**SITE PLAN AMENDMENT
STAFF REPORT**

Proposed Use: Site plan for PD-823 for Starbucks and retail

Companion Cases: ZC-08-122/PD-823/SP-15-001

SP-15-006

Design Staff's Sketch of a Modified Starbucks Project in Compliance with the MU-1 Ordinance.

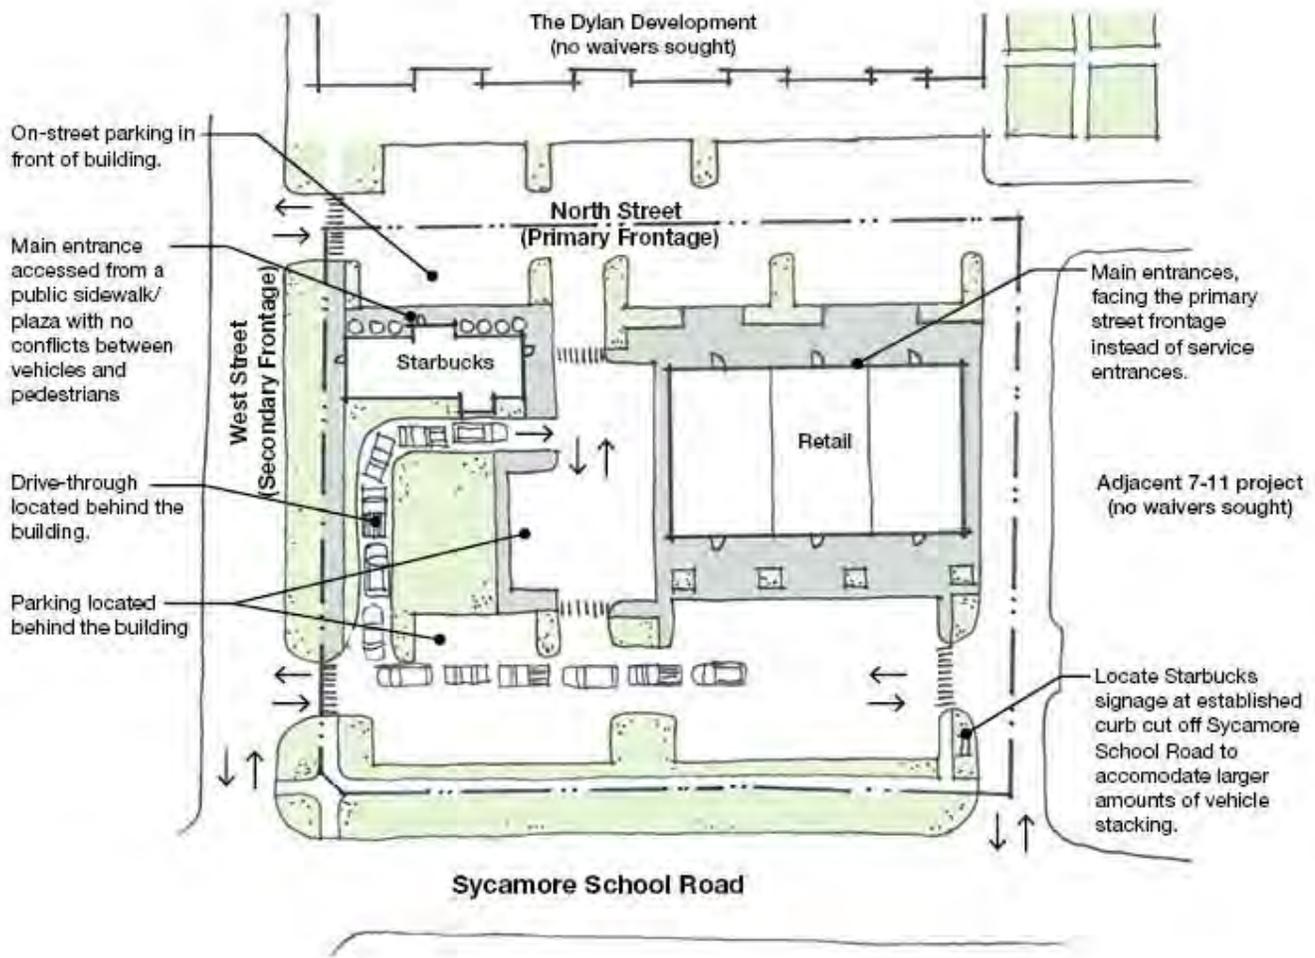
Site Plan before Meeting MU Standards

Site Plan after Meeting MU Standards

On two occasions staff provided the applicant with example site plans depicting easy changes that could be made that would require no/minimal waivers. The most recent sketch provided to the applicant is included here your reference. The example site layout would allow Starbucks to keep the original store's interior layout, accommodate Starbucks drive-through stacking requirements, and provide a pedestrian-oriented building front on the north façade. TPW staff has recommended that the drive-through window be relocated to provide queuing away from the driveway at Street "B" instead of turning the vehicles into it. The example site plan addresses this comment by relocating the drive through queuing away from Street B, thereby creating a more efficient traffic flow and accommodating a greater number of vehicular staking spaces in a safer, more efficient manner. The provided sketch is just one example that would require no waivers but still meet all the stated needs of the applicant's project. Instead, the case before you has a list of several waivers seeking to decline established standards of the City's mixed-use zoning ordinance.

PRELIMINARY SITE PLAN

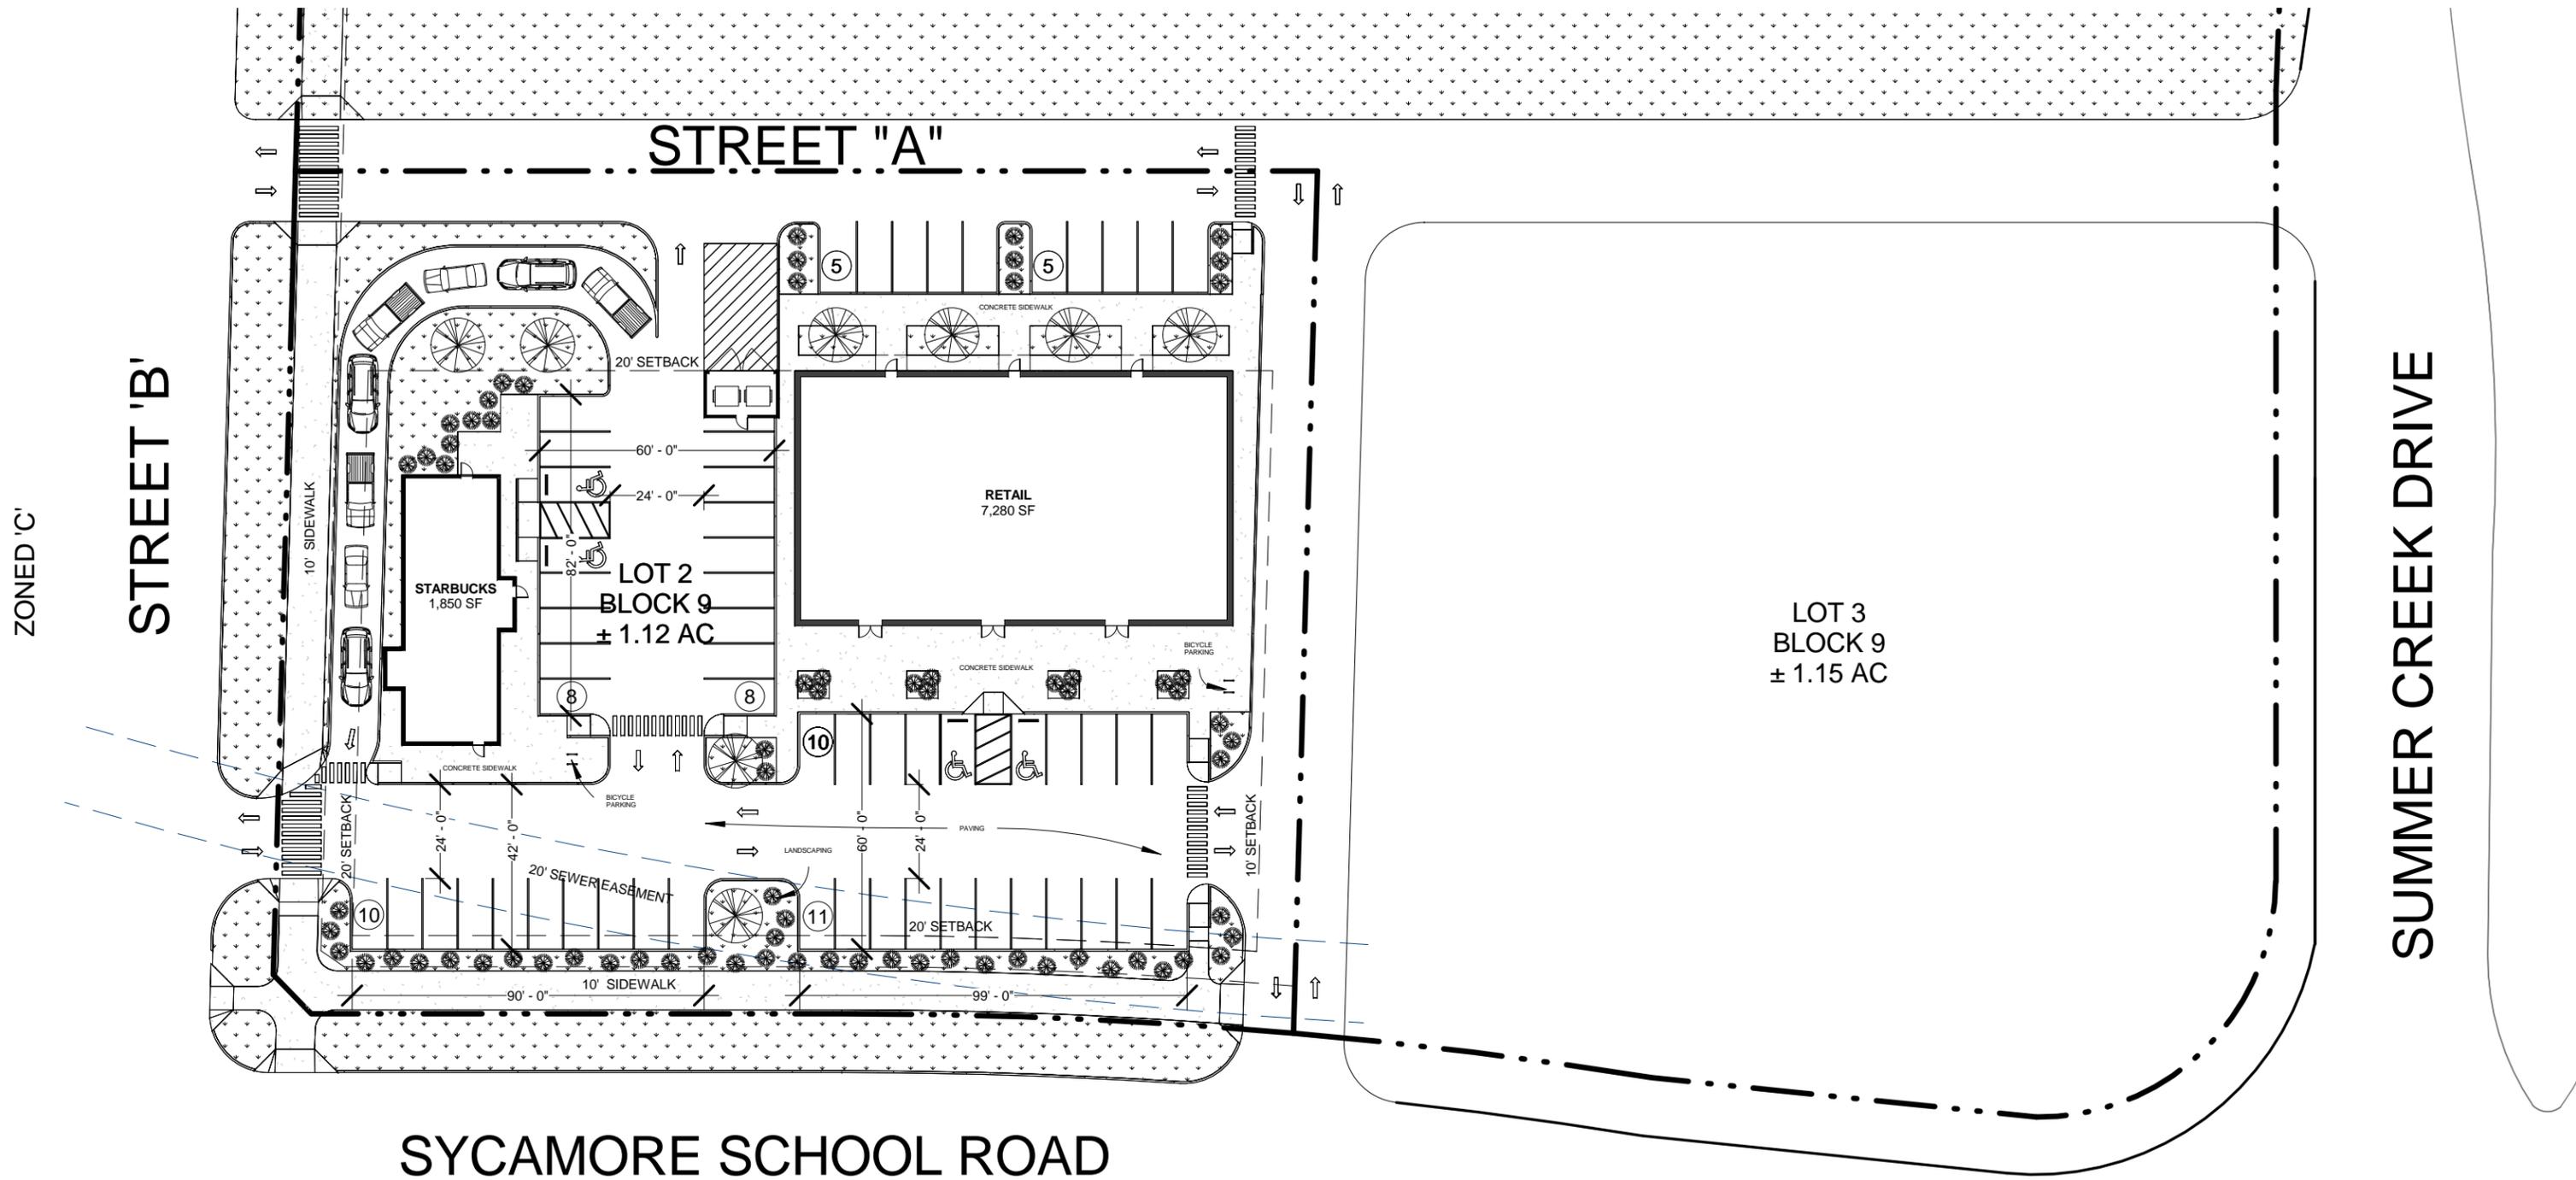
The site plan as submitted is in general compliance with the Zoning Ordinance regulations, except as provided below for Design Review Standards.

1. Site plan is dark and not legible
2. Parking cannot be counted within sewer easement
3. Provide location of sign if warranted

1. At 65 feet in depth, the proposed front yard setback on the primary street significantly exceeds the maximum allowed 20-foot setback. (*waiver requested*)
2. The project proposes no building frontage on the primary street *and* none on the secondary/side street, whereas MU-1 requires 50% building frontage on the primary street and 30% on the side street (*waiver requested*)
3. The proposed vehicular drive-through lane located between the building front and the street is not permitted in MU-1. (*waiver requested*)
4. The proposed vehicular drive-through lane as shown is located along both building facades that face streets to the north and west, which is not permitted in MU-1. The north portion of the drive-through is proposed to be located in the front yard setback between the building front and the street. (*waiver requested*)

5. None of the required building façade variation or scaling elements are proposed for either the Starbucks and the adjacent retail building. *(waiver requested)*
6. The proposed principal entrance for the Starbucks and the adjacent Retail Building are shown as being directly from parking lots, rather than from a public sidewalk or private sidewalk with a public use easement as required in MU-1. *(waiver requested)*
7. The rear service entrances to the Starbucks and adjacent Retail Building is currently proposed to face the primary pedestrian street to the north. To dress up the service entry, the door will be glass with an awning but it will remain locked and inaccessible to the public. MU-1 requires the principal entrances of buildings to be from a public sidewalk or private sidewalk with a public use easement, not from a parking lot. *(waiver requested)*

1. Access easements shall comply with the requirements of Section 31-106 (Street Standards) I (Access Easement Design Standards (Public Access Easements, Reciprocal access Easements, Private Drives or Ways) of the Subdivision Ordinance. Access easements are privately maintained but constructed to city street standards that are open to unrestricted and irrevocable public access and serve two or more lots each having a minimum of 100 feet of frontage as their primary means of access. The access driveway to the east of the property is to be a public access easement due to the adjacent lot not having independent access.

2. Sidewalks and street lights are required for all public and private streets and public access easements as per City of Fort Worth Standards. Show the location of street lights and sidewalks on this lot. Label the width of all sidewalks. ADA ramps across the driveways are not required. The sidewalks shall be continuous across the driveways.

3. The proposed driveway queueing does not allow for vehicles to flow from the site without blocking the access from the Starbucks window. It is recommended that the drive thru window be relocated to provide queueing away from the driveway at Street "B" instead of turning the vehicles into it.

4. It is recommended that a throat depth of 100 ft. be provided from the driveway on Street "B" before the parking spaces to keep vehicles from staking onto Street B and ultimately on Sycamore School Road (Principal Arterial) while vehicles are waiting for vehicles to exit the parking spaces. This is also true for the Public Access Easement.

5. The sidewalks shown are located within private property and a public pedestrian access easement will be required for the sidewalks located within the private property of the site.

6. Provide the dimensions of the parking areas and the driving aisles
